Interested Party:	DFO	No.:	1
Subject:	Freshwater Fish Community - Rascal Goose Lake Diversion and Watercourse Crossings

Memorandum

SUBJECT: Supplemental Information on Rascal Stream Realignment: Geomorphic Assessment of
Rascal Stream West

Rascal Stream West Channel Stability Assessment

Figure 1

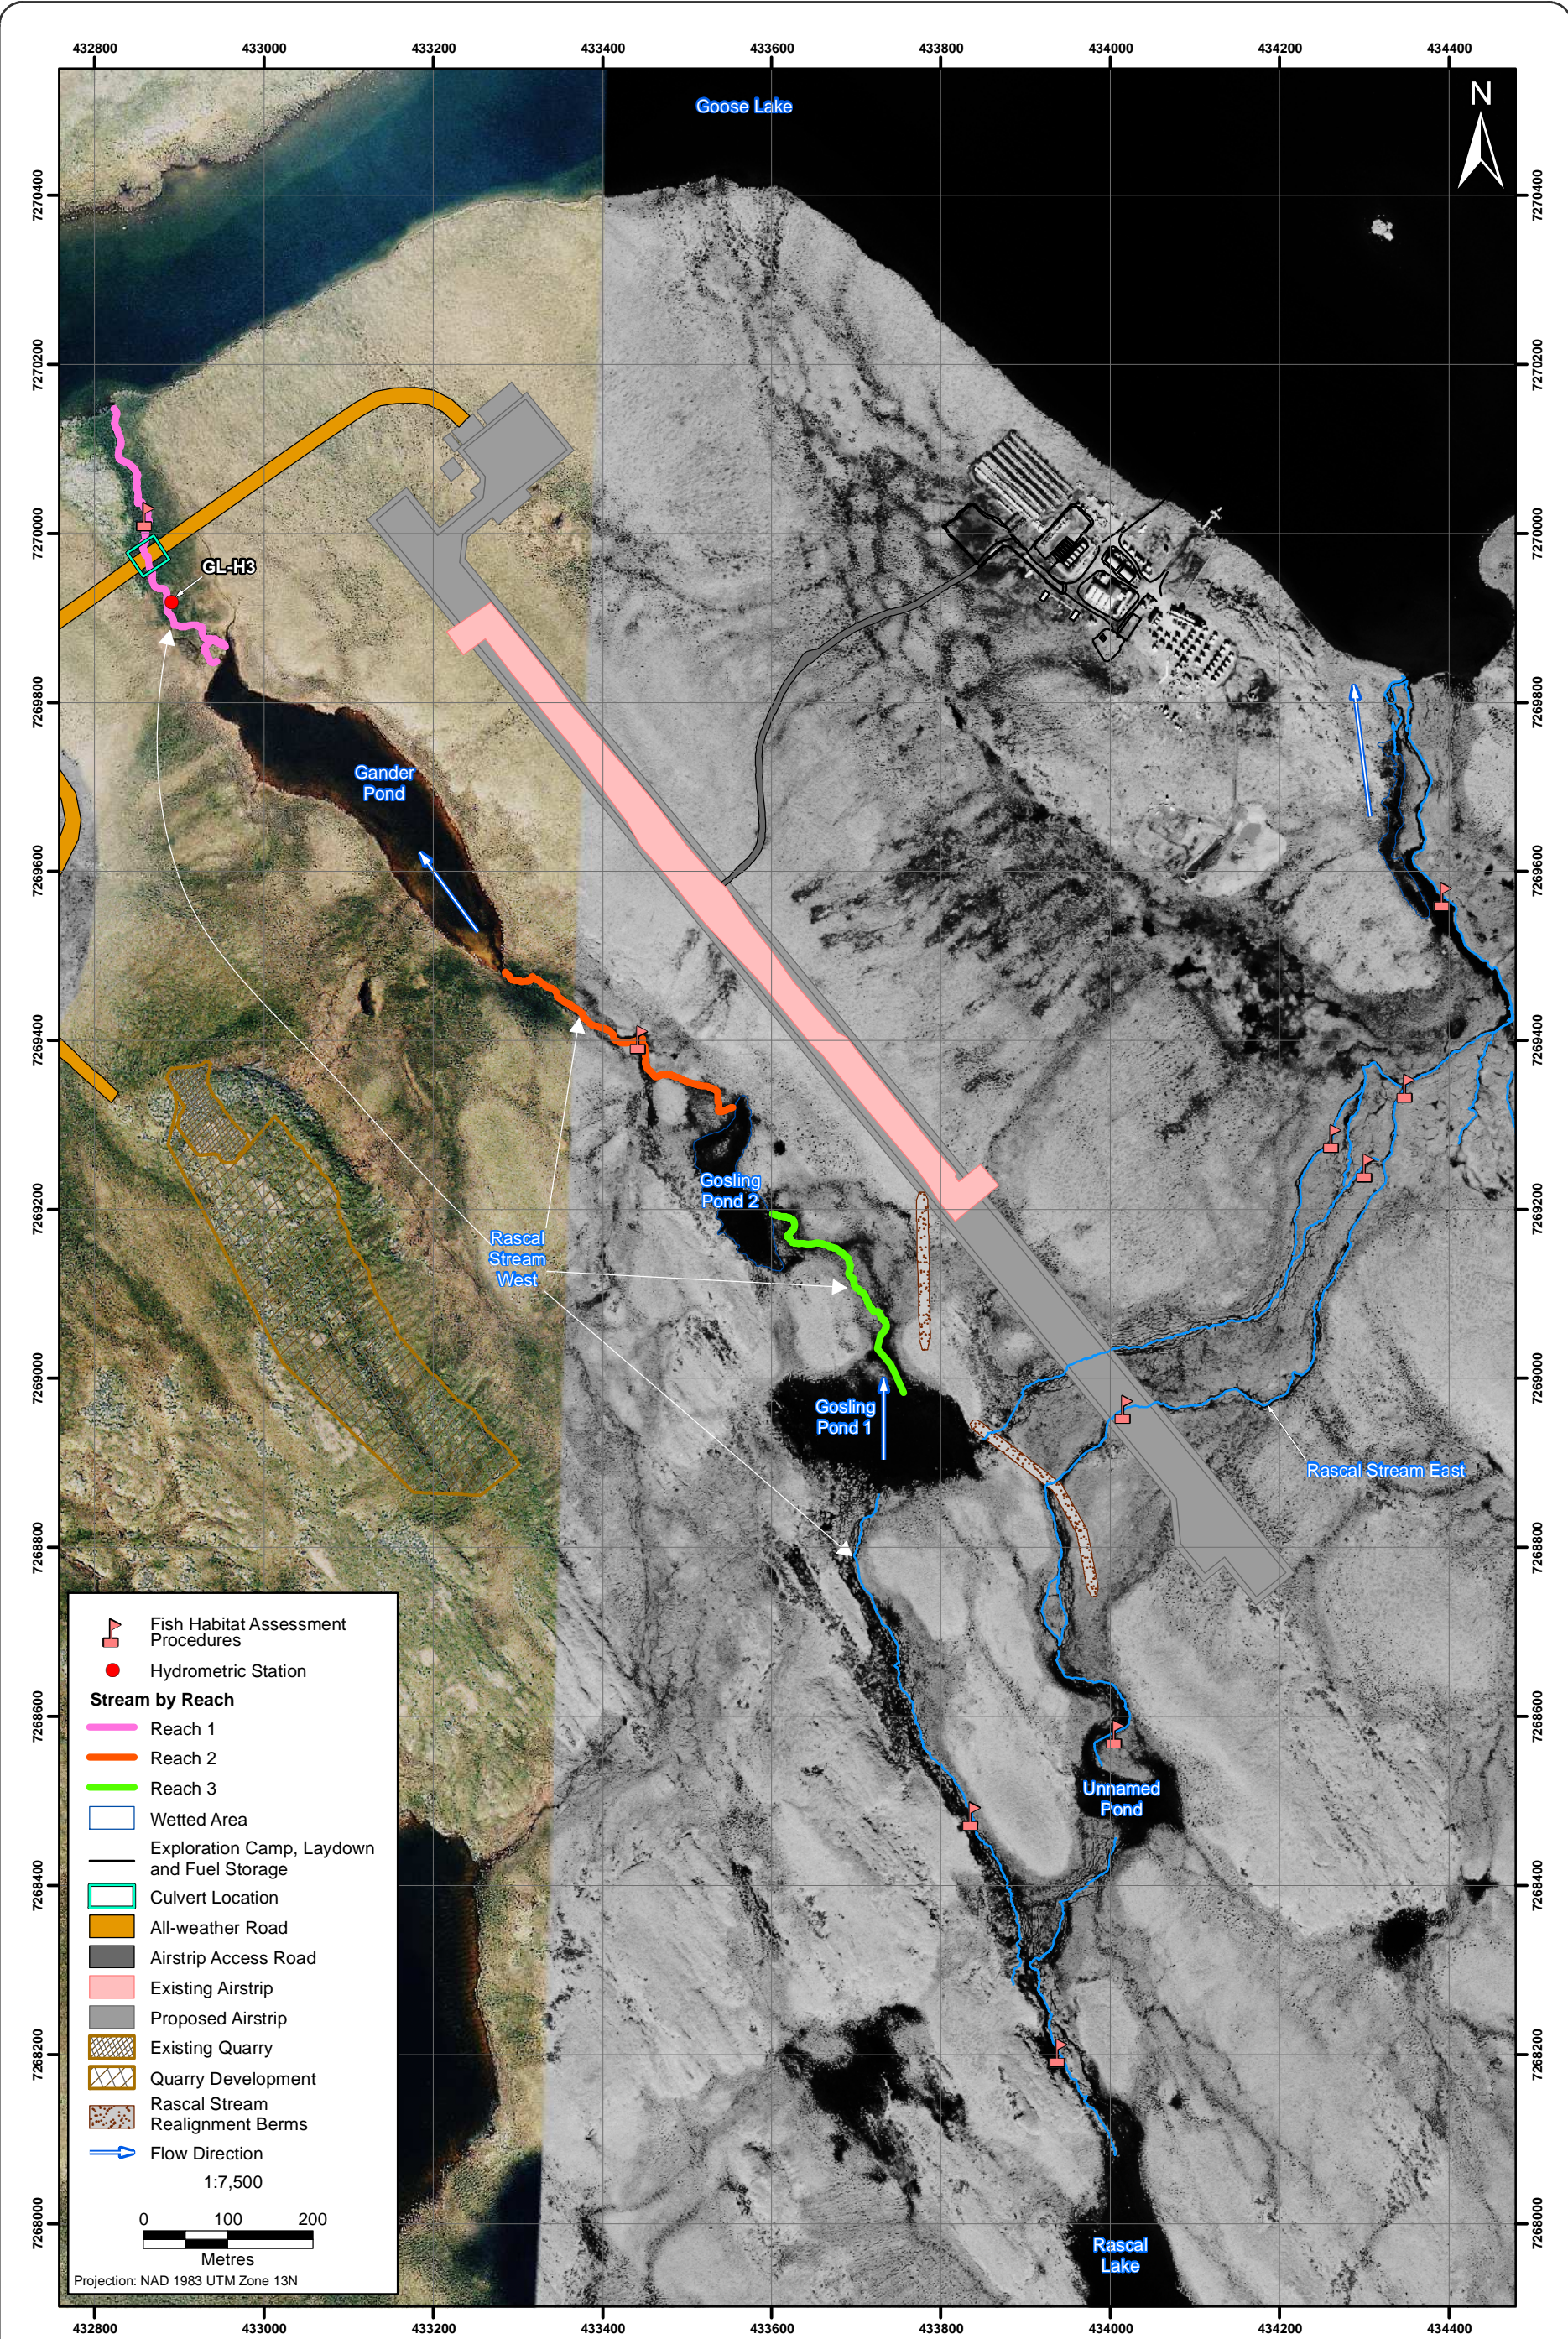
In response to DFO technical review comment 3.1.1 Sabina provided DFO with Appendix K - Back River Project - Fisheries Assessment of Rascal Stream Realignment. At the technical meeting for the Back River Project held on November 13-15 2014, Sabina made additional commitments (#22-24) based on technical comments which arose from DFO's review of Appendix K. Sabina committed to providing this information in the NLCA 12.10.2 (b) Exception Application however this information has not been received.

22. As part of the Site Preparation Application and in the FEIS, Sabina commits to provide DFO and other parties with supplemental information on how the Rascal stream realignment may affect the following: existing channel stability and erosion potential; the potential for re-suspension of sediments in ponds; and areas with undefined channels.

In order to address how the Rascal Stream Realignment might affect channel stability and erosion, a geomorphic assessment of Rascal Stream West was conducted. Two Rapid Geomorphic Assessment models along with a simplified hydrologic model were used to address channel stability and erosion, and the methodology and results are presented in this memo.

Channel stability and erosion potential was assessed on Reaches 1 and 2 of RSW (Figure 1; Plates 1, 2). Reach 3 is the area between Gosling Pond 1 and 2, and this area was not included in the modelling as the area is not channelized and hence there are no pre-existing field data. Reaches 1 and 2 of RSW had fisheries assessments conducted on them during the 2013 field seasons (Rescan 2014) and therefore contained the data required to conduct desktop RGAs to assess channel stability and erosion potential.

Reach 1 is the Gander Pond outflow stream and Reach 2 is the Gander Pond inflow stream (Figure 1). During the 2013 fisheries assessment of RSW for the airstrip realignment (Rescan 2014), standard Fish Habitat Assessment Procedures (FHAP) were performed on Reaches 1 and 2 of RSW. Data inputs for the RGAs and the simplified hydraulic model, to supplement the RGAs, were obtained from these FHAP assessments, the surface hydrology field program (various hydrology baseline reports; see the DEIS for the baseline reports; Rescan 2013) and the SRK hydraulic study conducted to support the fisheries assessment (see Appendix 2.1 in Rescan 2014).
